ENTECH
ENGINEERING, INC.

**WASTEWATER STUDY
RETREAT AT TIMBERRIDGE FILING NO. 4
PARCEL NO. 52220-00-023
EL PASO COUNTY, COLORADO**

Prepared for:
**TimberRidge Development Group, LLC
2138 Flying Horse Club Drive
Colorado Springs, CO 80921**

December 21, 2023

GEOLOGY / ENGINEERING MAP

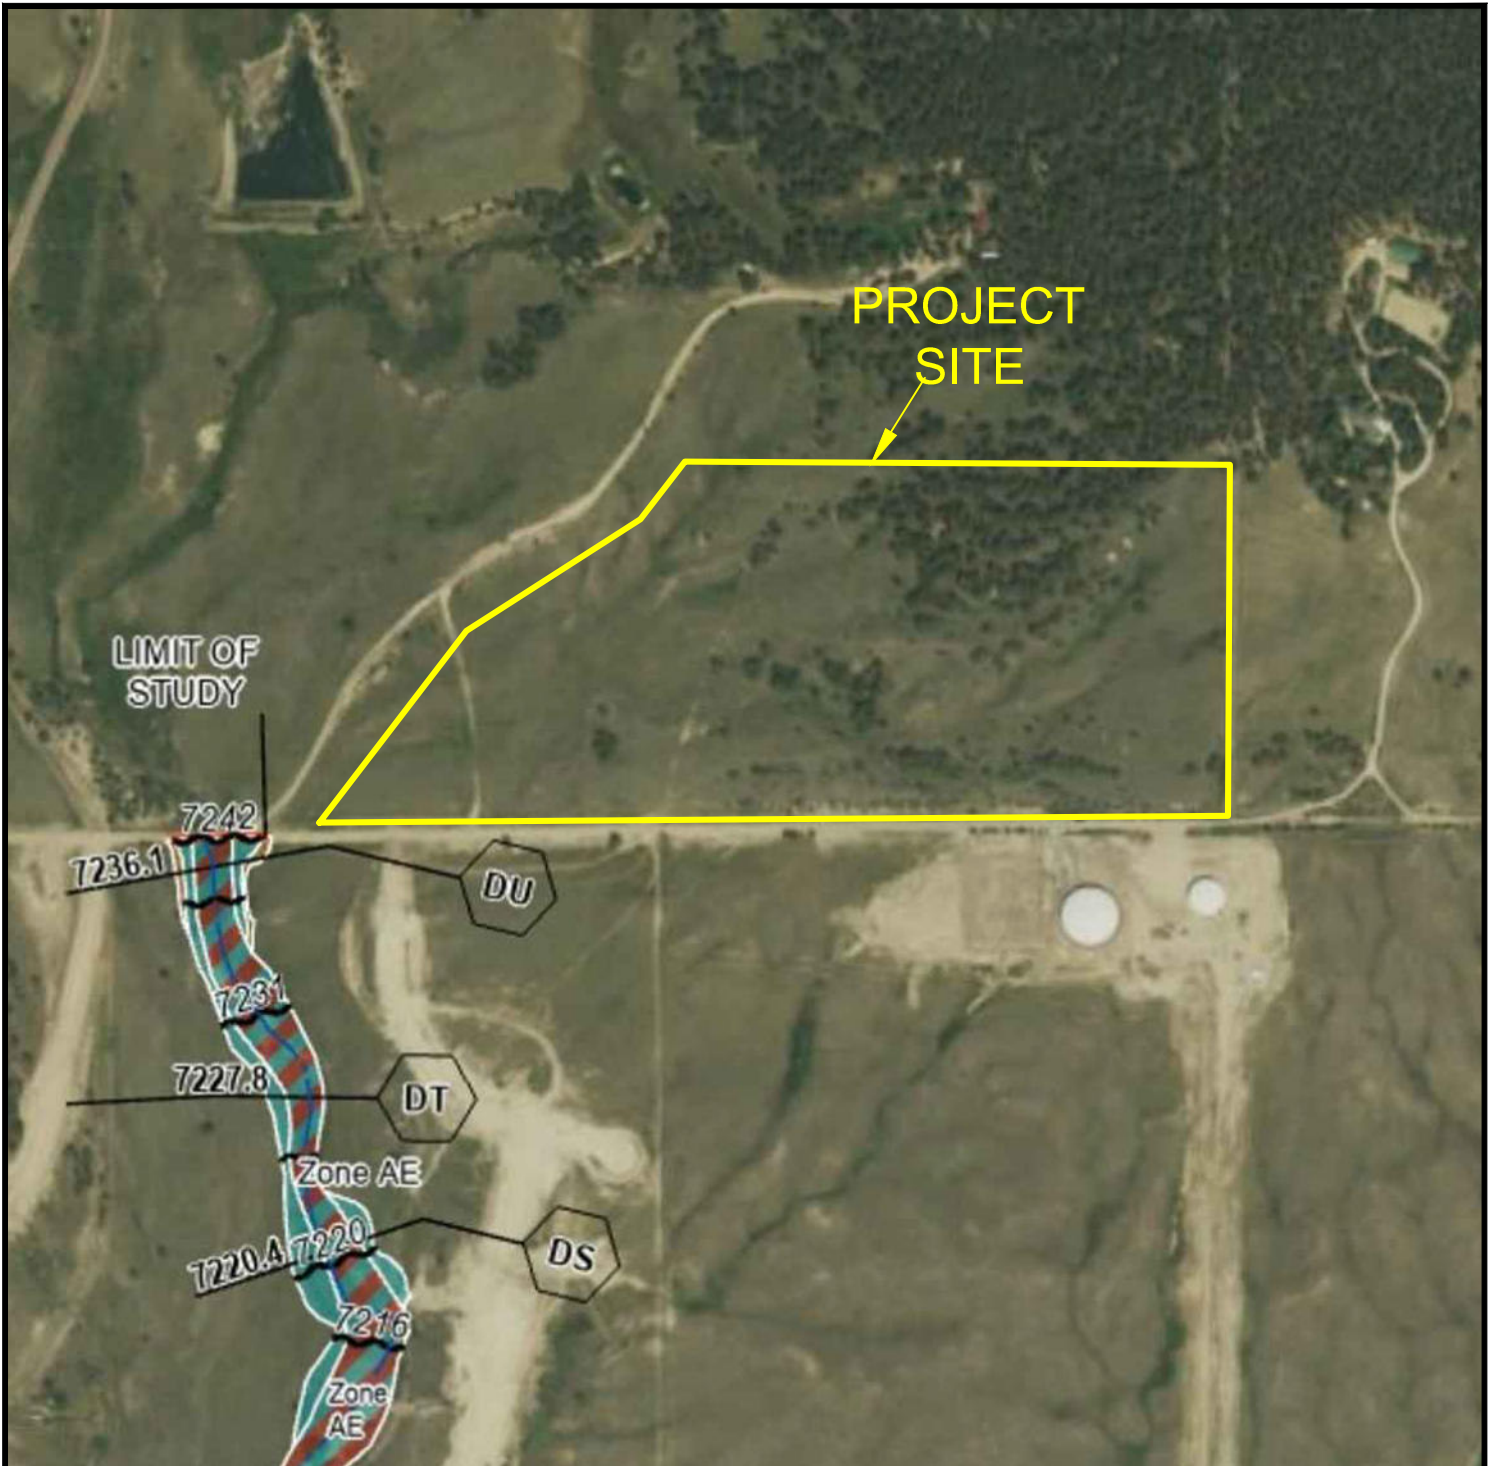
There is a strip of potentially seasonally shallow groundwater located along the pond embankment, how will this be mitigated? See excerpts from MHFD's DCM Volume 2 and 3 for potential concerns with groundwater in an EDB and the recommended mitigation options (like a clay or geomembrane liner). Please discuss this potential shallow groundwater in the report text. If you decide not to design for mitigation now and shallow groundwater is encountered during or after construction (or at PA/FA), proper mitigation and permitting will need to be implemented at that time
